Product Change Notice (PCN)

PCN Number: PCN-0456200R-01

Product(s) Affected: SJ1-351X Series (Parts: SJ1-3513, SJ1-3514 & SJ1-3515)

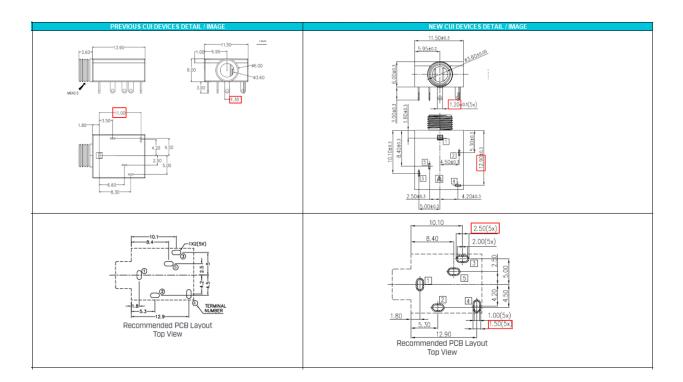
Description of Change: New Factory Location. Product re-engineered for improved manufacturability and production yield. See image below for reference and check CUI Devices website for updated drawing. Cosmetic differences may be visible and will not affect the form fit and function of the product.

PF	REVIOUS CUI DEVICES DE	TAIL / IMAGE			NEW CUI DEVICES DETAIL	. / IMAGE
DESCRIPTION	MATERIAL	PLATING/COLOR		DESCRIPTION	MATERIAL	PLATING/COLOR
terminal 1	brass t=0.3	silver		terminal 1	brass t=0.3	silver over nickel
terminal 2	phosphor bronze t=0.3	silver		terminal 2	copper alloy t=0.25	silver over nickel
terminal 3	brass t=0.3	silver		terminal 3	copper alloy t=0.25	silver over nickel
terminal 4	brass t=0.3	silver		terminal 4	brass t=0.3	silver over nickel
terminal 5	phosphor bronze t=0.3	silver		terminal 5	brass t=0.3	silver over nickel
bushing	brass	nickel	-	bushing	brass	nickel
spring	steel	black		cover	PBT (UL94V-0)	black
cover	PBT (UL94V-0)	black		housing	PBT (UL94V-0)	black
housing	PBT (UL94V-0)	black		nut	brass	nickel
nut	zinc alloy	tin		Hut	กเสรร	HILKEI
